SERVICE BULLETIN

Reference: TECHNICAL BULLETIN TS86-112		Date: June 26, 1986
Classification: Exhaust Gas (O2) Sensor	Section: Emission Control	Models: 1982 Gasoline Maxima

SPECIAL SERVICE CAMPAIGN, EXHAUST GAS SENSOR - 1982 NON-TURBO 280ZX, GASOLINE MAXIMA

1982 Maxima (910)

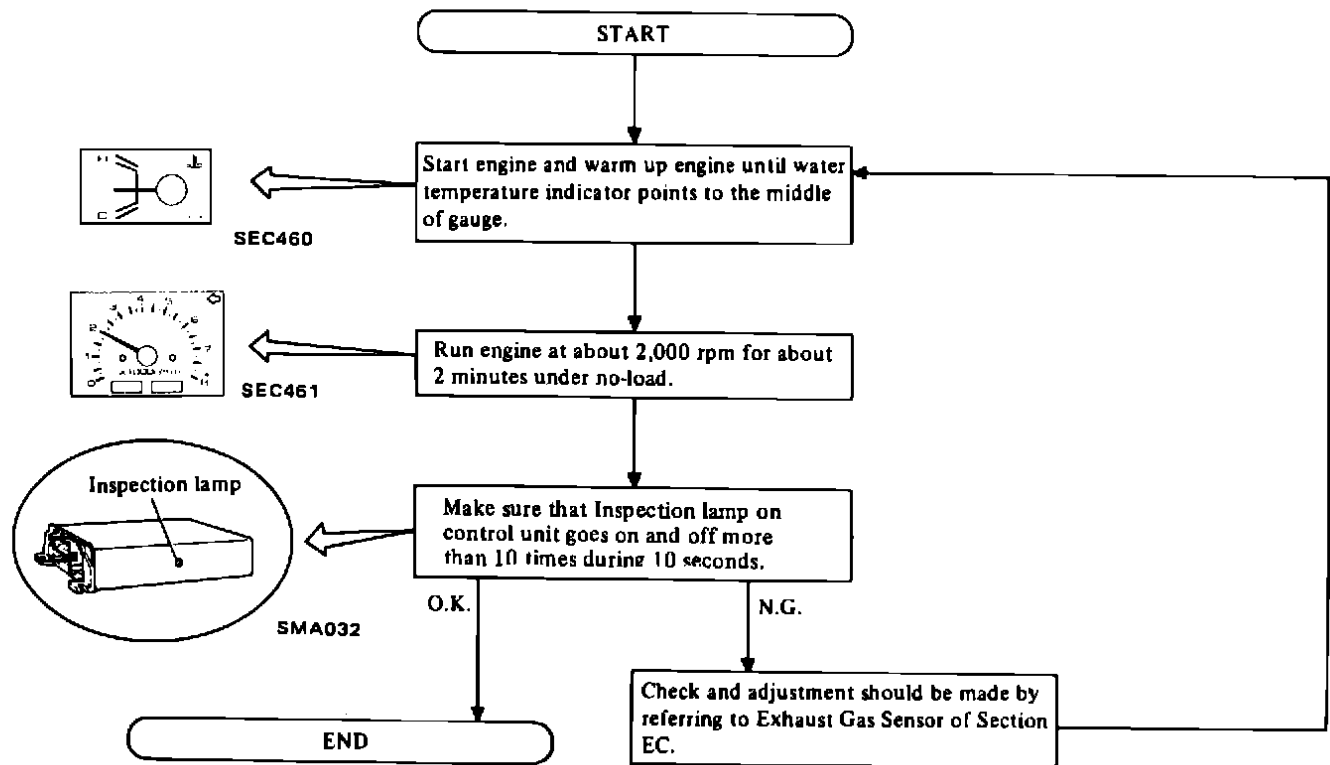
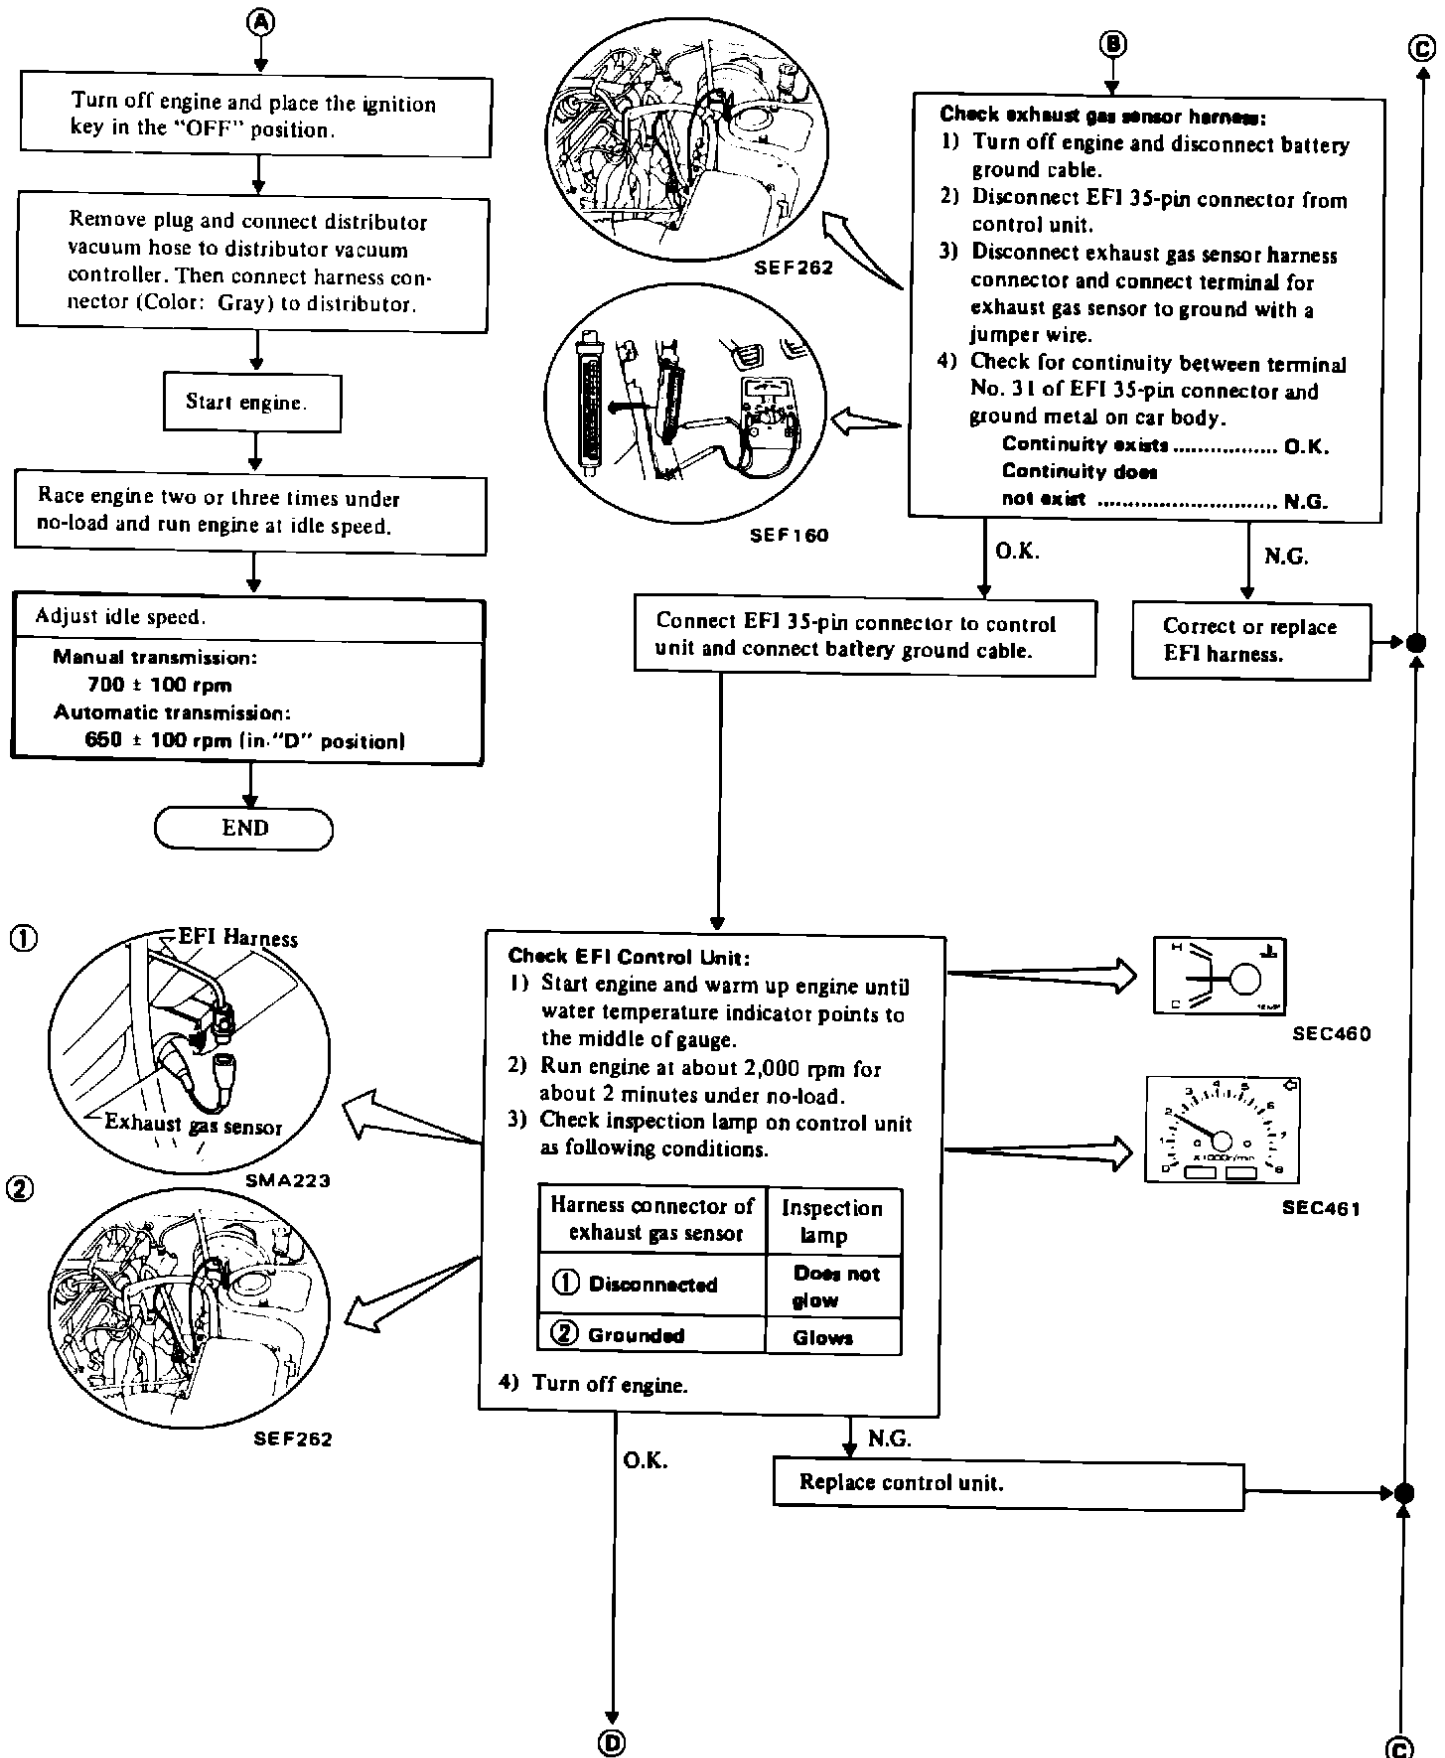
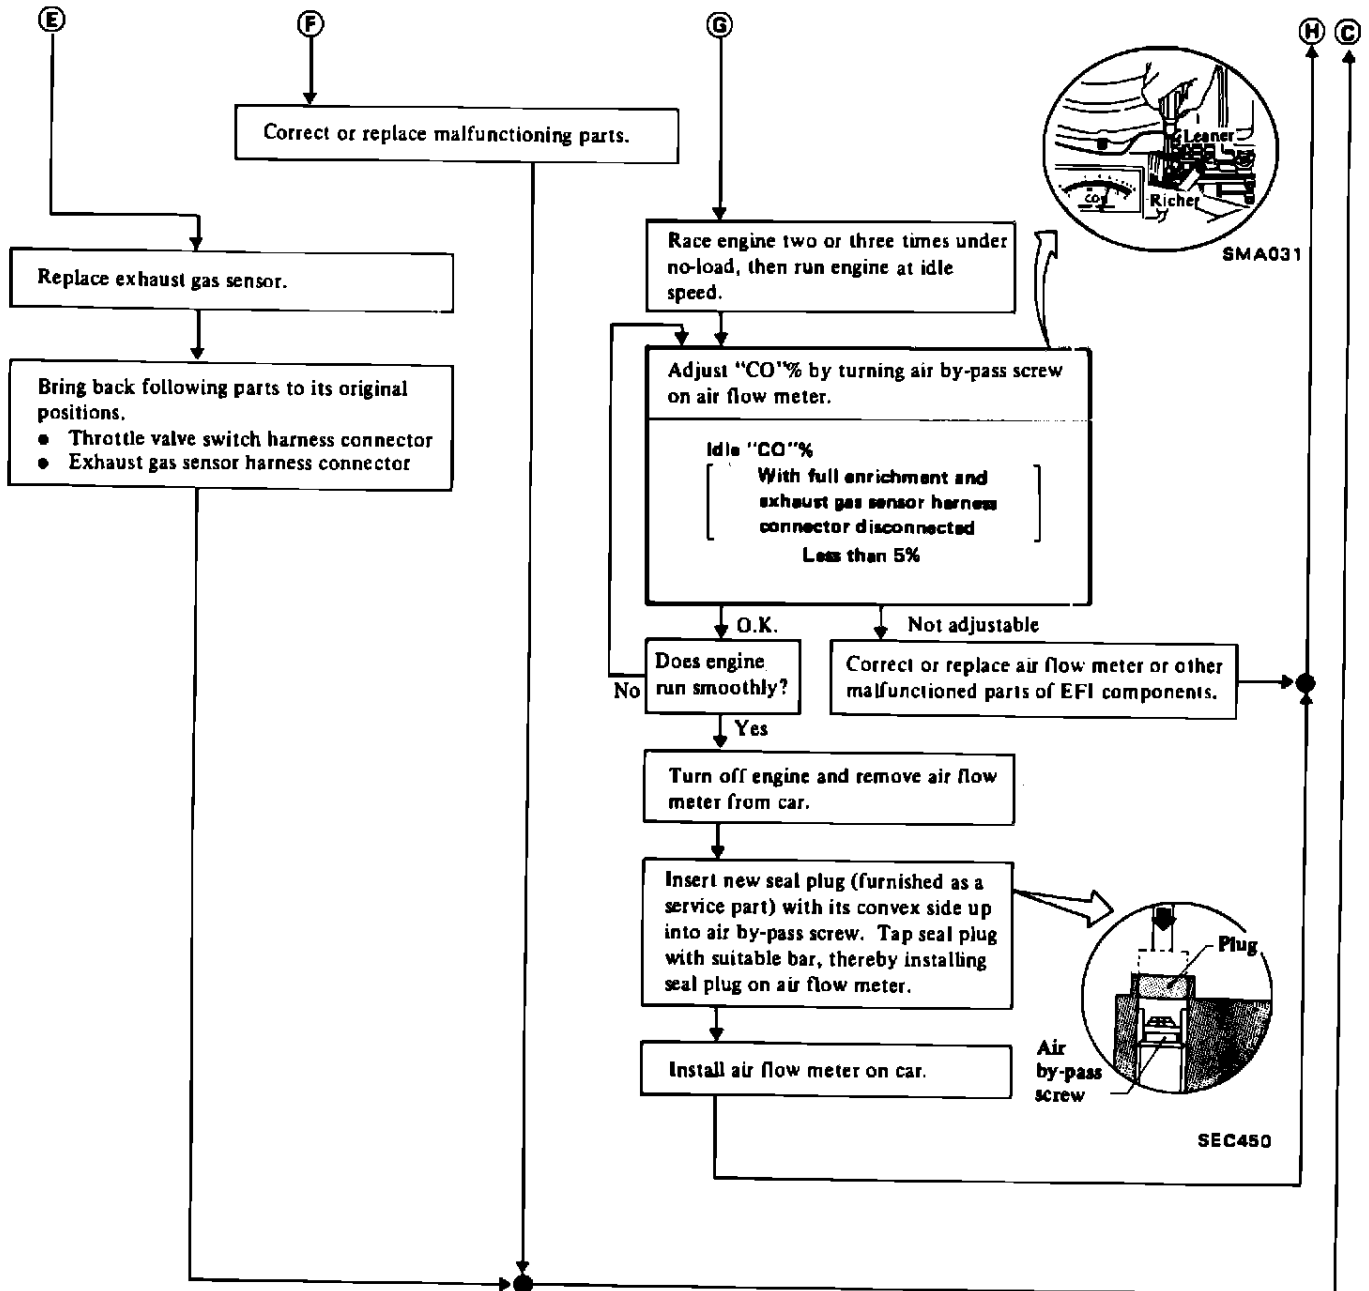
In conjunction with this service campaign, pages MA-13 and EF&EC-43 of the 1982 280ZX Service Manual and pages MA-15 and EC-13 of the 1982 Maxima Service Manual (the step which refers to counting the number of times the inspection lamp on the EFI control unit goes ON and OFF) should be revised as follows:

The procedure for inspecting the exhaust gas sensor is the same as printed in the Service Manuals for the 1982 Non-Turbo 280ZX and Gasoline Engine Maxima with the exception of the revision to the step involving counting the number of times the inspection lamp on the EFI control unit goes on and off. The appropriate pages in the Service Manuals with the change incorporated are printed below for your convenience.

Make sure that inspection lamp on control unit goes on and off more than 10 times during 10 seconds.
